Service Manual

CD Stereo System

Model No. **SA-AKX74PH**
SA-AKX74PN
SA-AKX94PH
SA-AKX74PR
SA-AKX94PR

Subject : Updates on Block Diagram, Schematic Diagram, Printed Circuit Board, Exploded View & Parts List.

SC-AKX74PH/PN-K
PACKAGING DRAWINGS

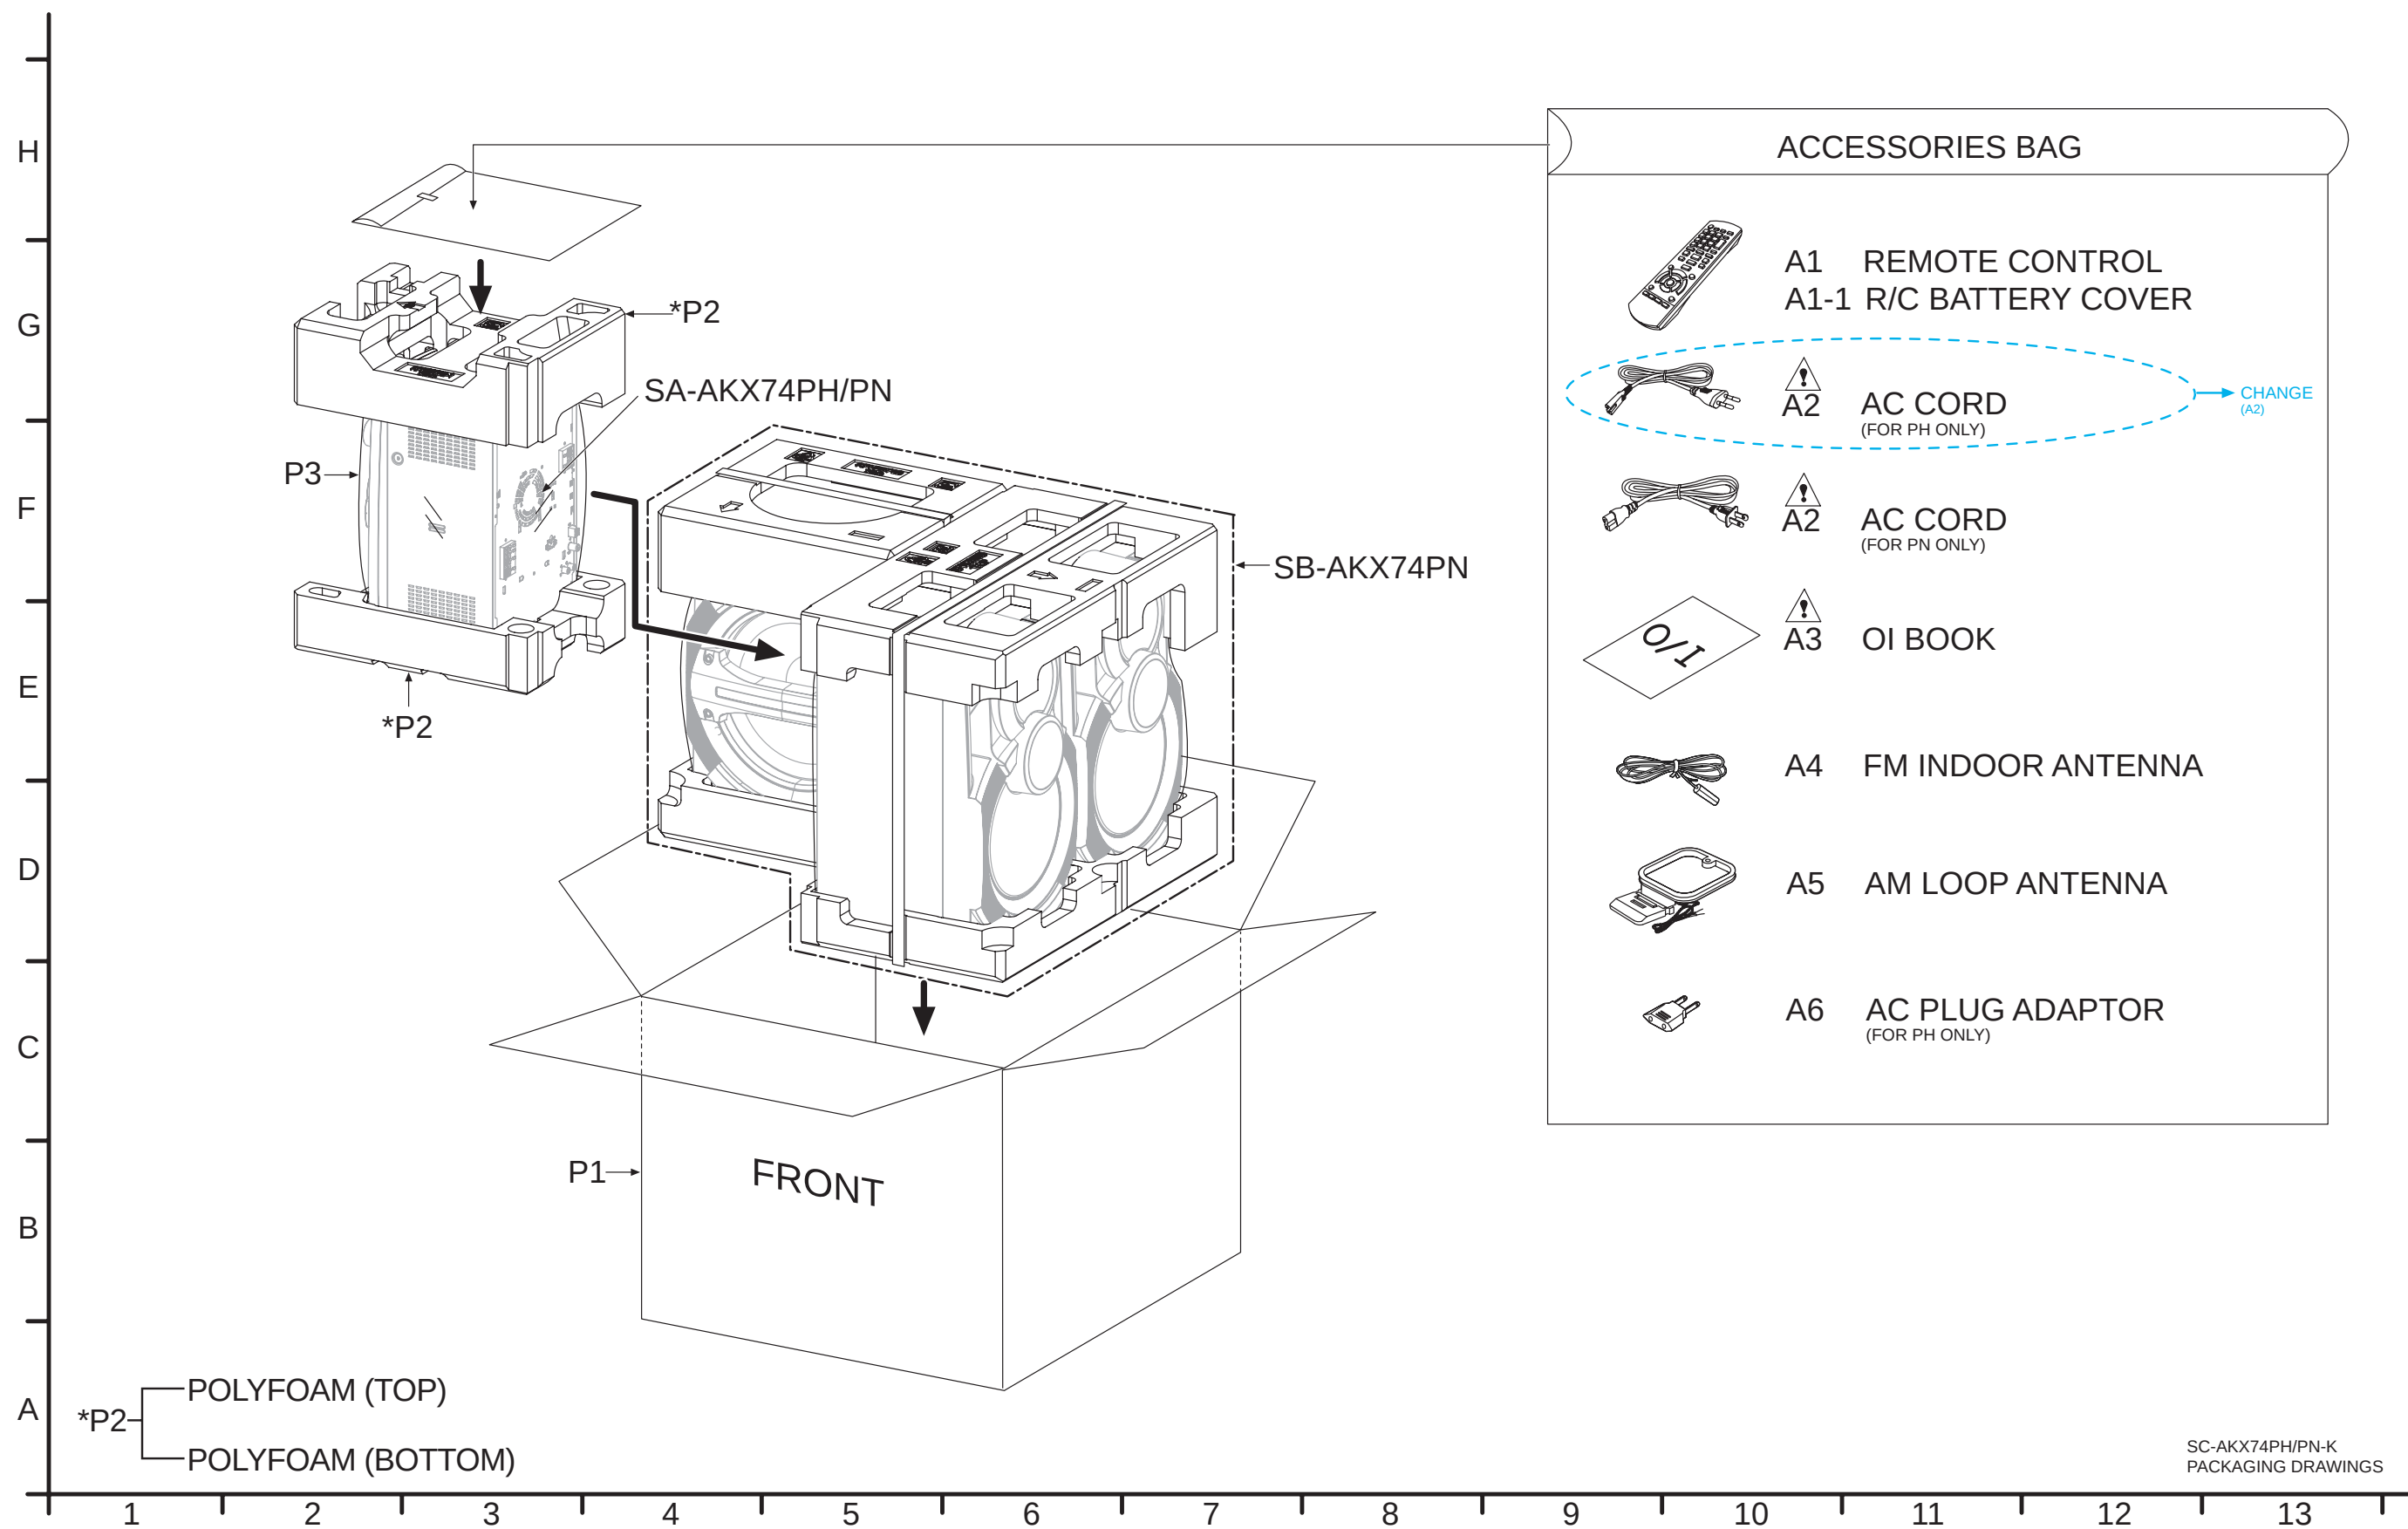
With reference to original service manual (section 19.1.2) on page 125.

5.2. Packaging (SA-AKX94PH-K)

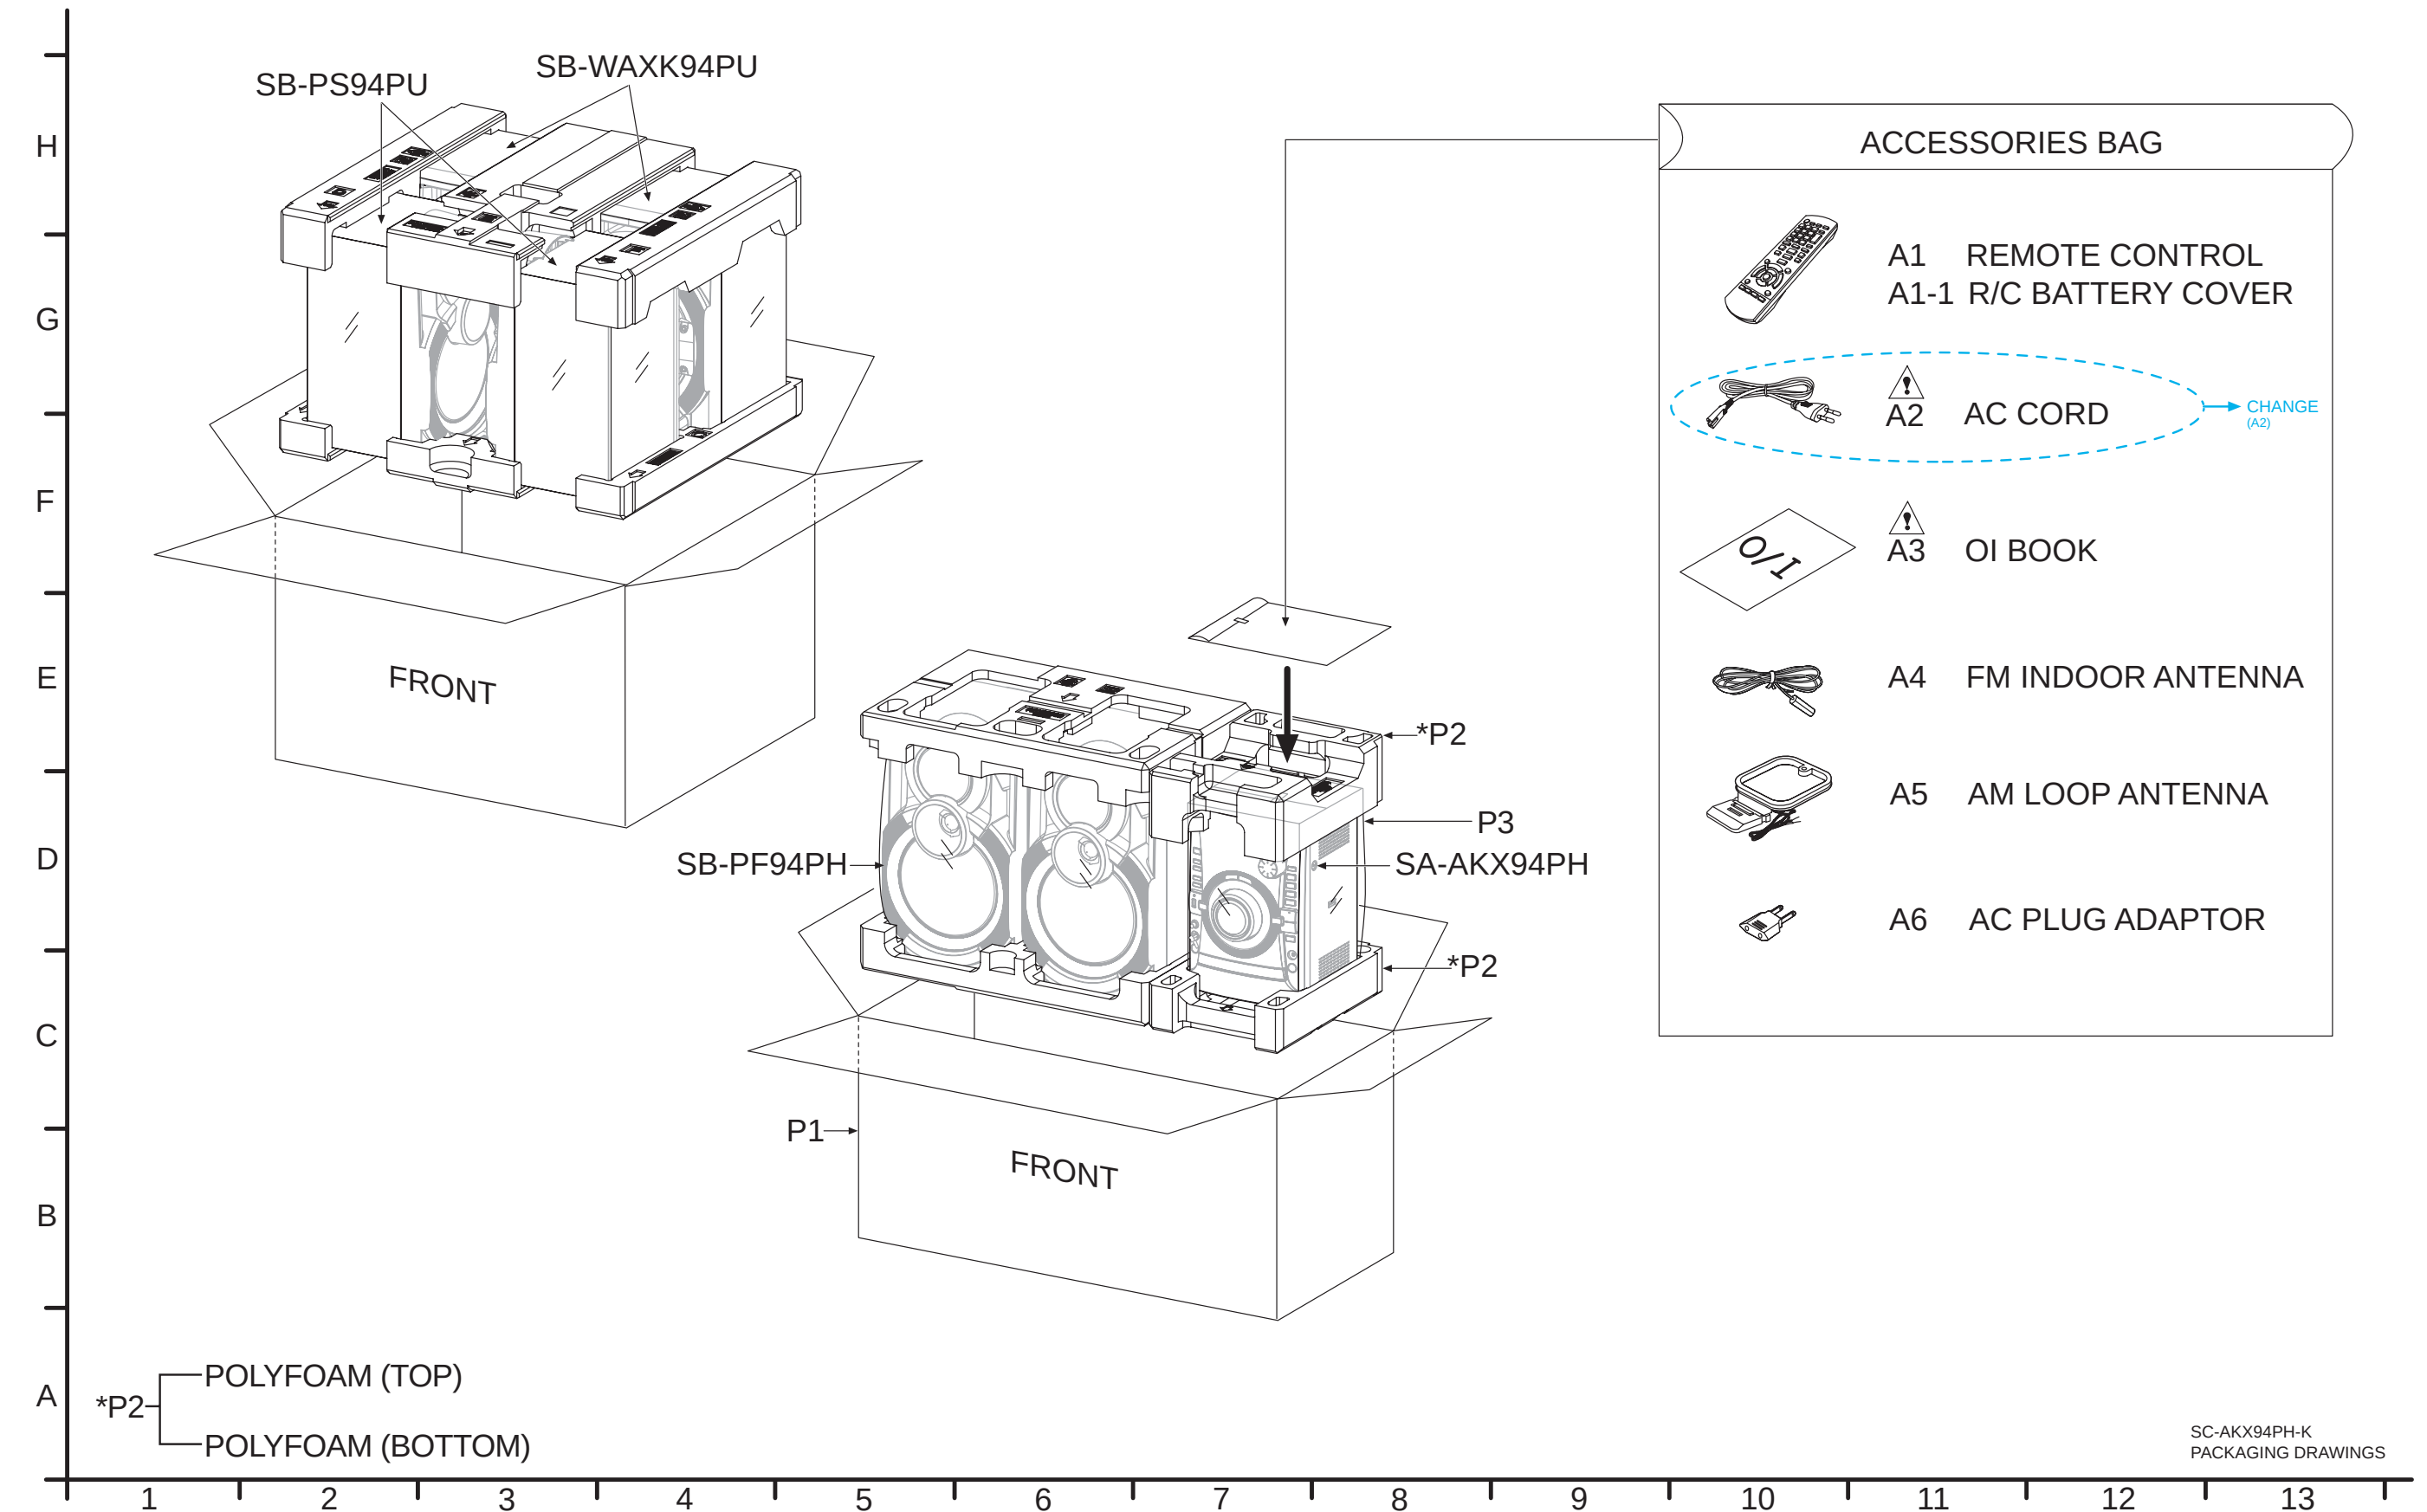
With reference to original service manual (section 19.1.2) on page 135.
